Zoning Staff Report

Date: November 14, 2023 Case Number: ZC-23-138 Council District: 4

Zoning Map Amendment & Site Plan

TOWNE PLACE & SPRING HILL DUAL BRAND by MARRIOTT:

SITE PLAN SCALE= 1"=40'-0" DOCUMENT DATED: 08/27/2023

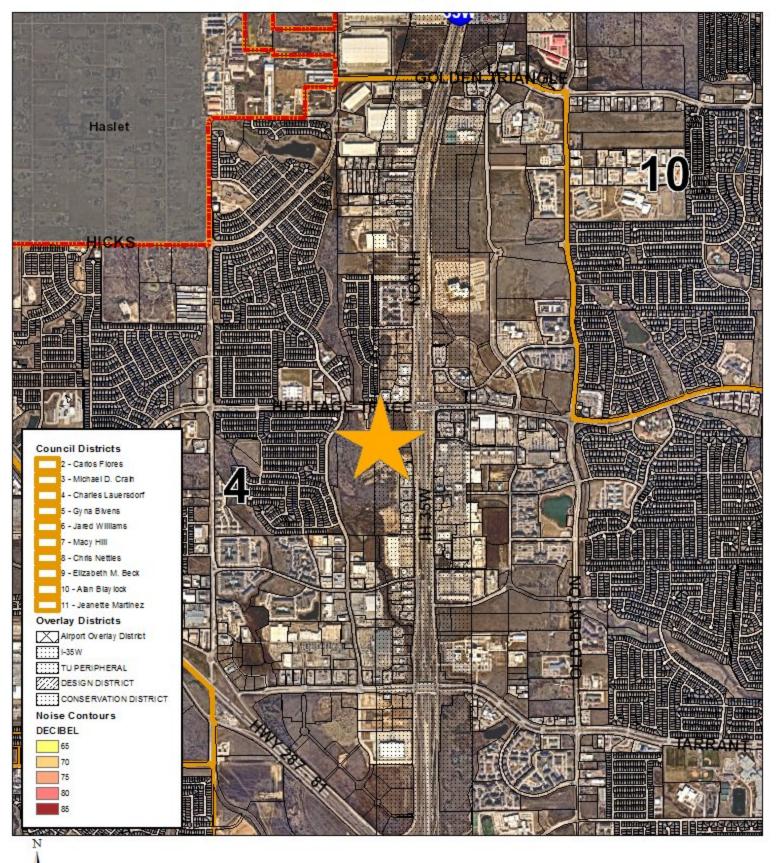
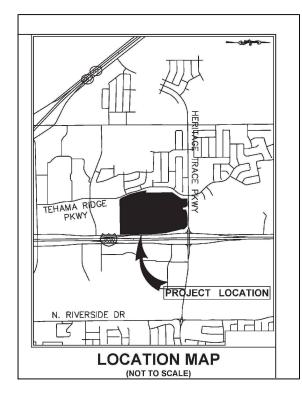
- Add case reference ZC-23-138 to lower right corner.
- Signature line should be for "Director of Development Services"
- Remove proposed monument sign from plans (signage is permitted in a separate process).

- Add address "2752 Citadel Spring Drive" under the legal description.
- Confirm you have discussed your proposal with the City's Urban Forestry section and can meet or exceed their minimum requirements.

- Confirm you have discussed the I-35W overlay standards with the City's Preservation & Design section and can meet or exceed their requirements.
- Confirm that you are not seeking any development standards (aka 'waivers') from the "G" Intensive Commercial requirements found in Section 4.904 of the Zoning Ordinance, with the exception of the parking waiver.

- Add note that "This development will meet or exceed all "G" standards in Section 4.904 of the City of Fort Worth Zoning Ordinance, with the exception of the reduced parking".

- Remove general notes 6, 7, and 8 (redundant).
- Amend general notes 1 & 2 to say "conform" rather than "confirm".
- Amend general note 5 to say "We are requesting a development standard for reduced parking".

- Amend note at bottom of Required Parking section to read "We are requesting a development standard to reduce the required parking amount by 23 spaces".

- FYI note waivers are formally called "development standards" in the Fort Worth Ordinance, so the terms refer to the same thing but need to use the formal language of "development standard(s)" instead of waiver(s) throughout.

Unless private hydrants are present on the lot, additional hydrant(s) will be required to meet the following:

Maximum of 600 ft. (300 ft. radius) of space between hydrants along a direct horizontal line.

Maximum of 500 ft. hose lay distance to all points of building.

FDC's for sprinkler and standpipe systems shall be located within 50 ft. of a dedicated street or fire apparatus access road and shall be within 150 ft. hose lay distance of the nearest fire hydrant. Each building shall be equipped with its own FDC, unless otherwise approved by the fire code official.

Fire Sprinkler Systems will be required.

Additional requirements apply if the floor level of the highest occupied floor is taller than 55' from the lowest level of Fire Department access.

All comments sufficiently addressed as of 9/28/202.
